## PACIFIC ROCK QUARRY EXPANSION PROJECT

# **FINAL ENVIRONMENTAL IMPACT REPORT**

*STATE CLEARINGHOUSE NO. 2017081052*

### **VOLUME I – MAIN DOCUMENT**

#### **Errata 7. Revisions to Figure 3.8-2**

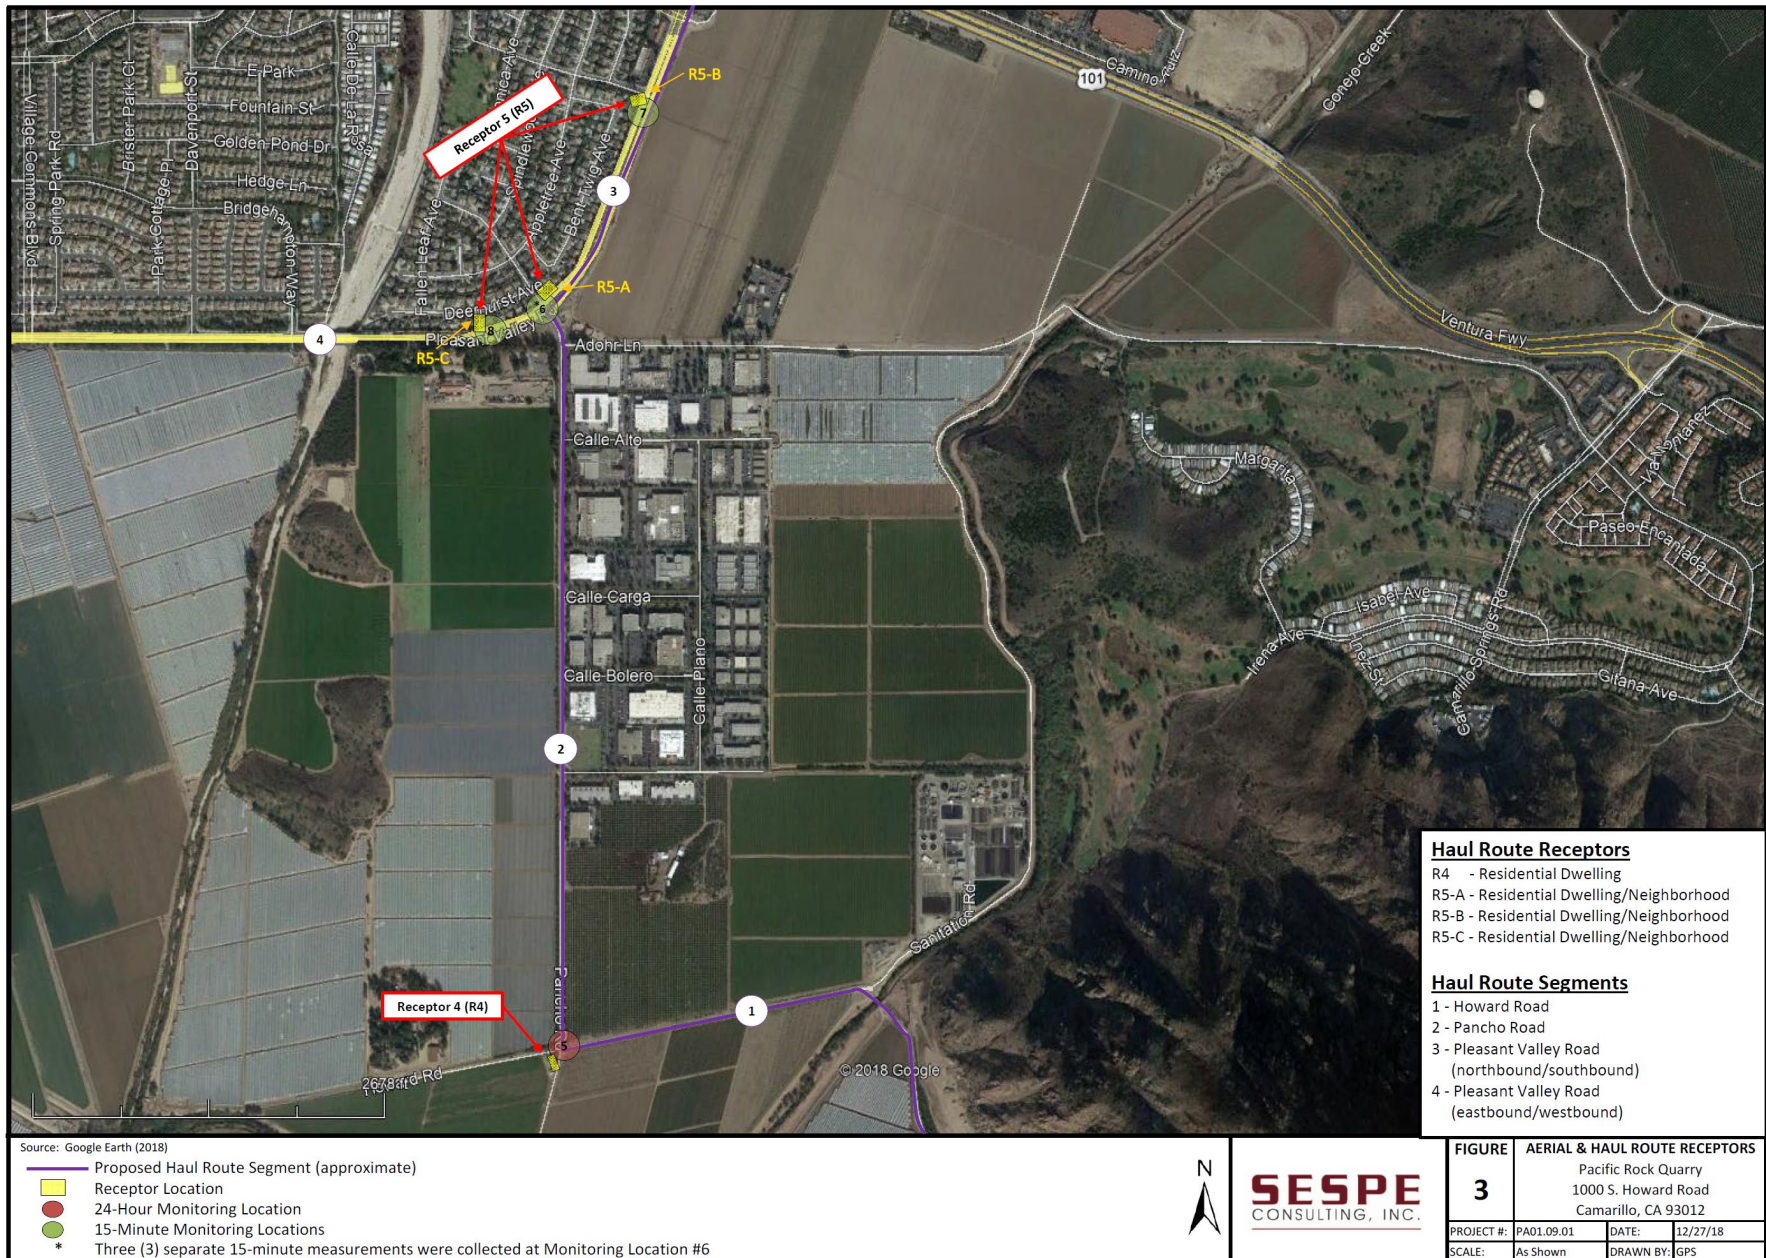
<sup>1</sup> DEIR Figure 3.8-2, Representative Receptors for Offsite Noise Analysis, incorrectly labeled Receptors R4, R5-A, R5-B, and R5-C as R3, R4-A, R4-B, and R4-C, respectively. Figure 3.8-2 is corrected in errata included in Chapter 3 of this FEIR. The figure labels do not affect the adequacy of the DEIR noise analysis.

DEIR Figure 3.8-2, “Representative Receptors for Offsite Noise Analysis,” incorrectly labeled Receptors R-4, R5-A, R5-B, and R5-C as R3, R4-A, R4-B, and R4-C, respectively. Figure 3.8-2 has been revised for this FEIR to correctly label these receptor locations. The revised figure is included at the end of this chapter. The figure labels do not affect the adequacy of the noise analysis or conclusions of the DEIR.
